Volvo Chassis - Model VNL, VNR - DEF Fill Door Loose, Vibrating, Broken - Repair Information

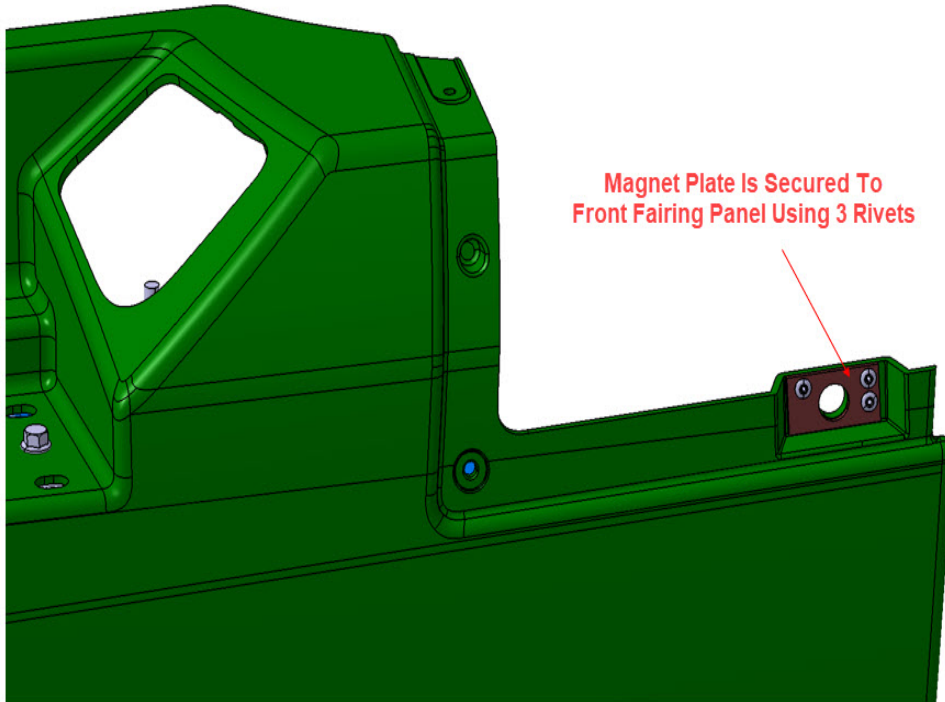
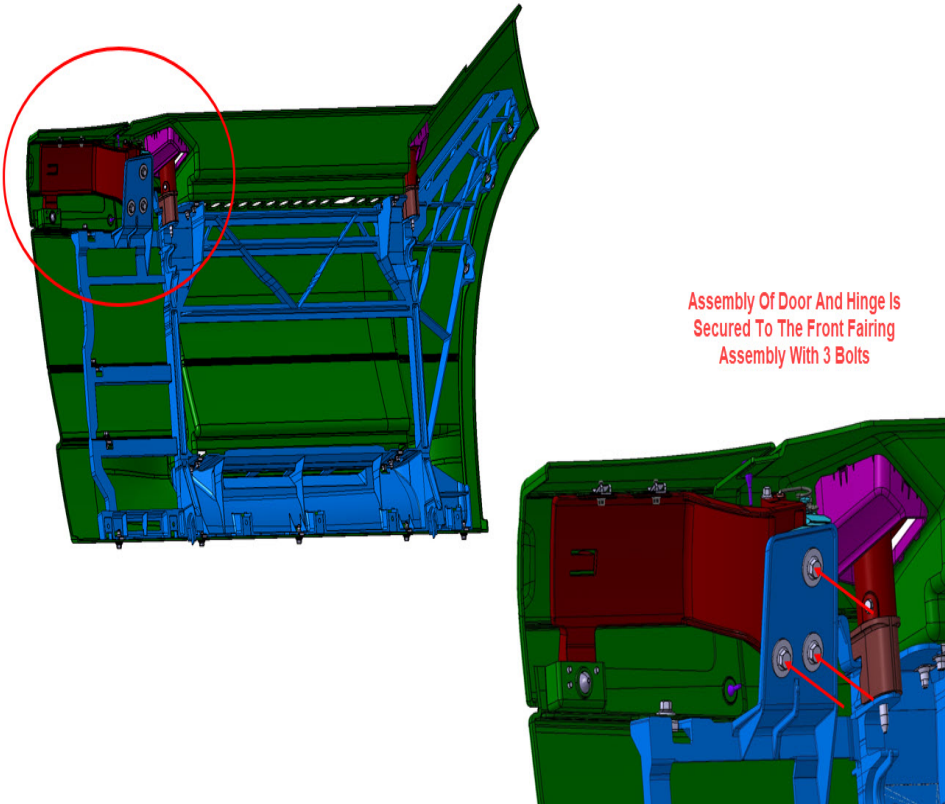
On certain VNL and VNR model Volvos built [August 21st, 2017 through January 01, 2021](#) and equipped with chassis fairing p/n 84744212 or 84744213, the DEF fill door in the fairing may become loose or break. A new magnet plate has been introduced to address this issue. The previous style plate Volvo p/n 84744218 comes installed in fairing p/n 84744212 or 84744213 and will have to be removed by drilling out the rivets. The new plate will then be riveted into place.

Door hinge assembly slides into the backside of the door panel and is secured with 2 fasteners at the top
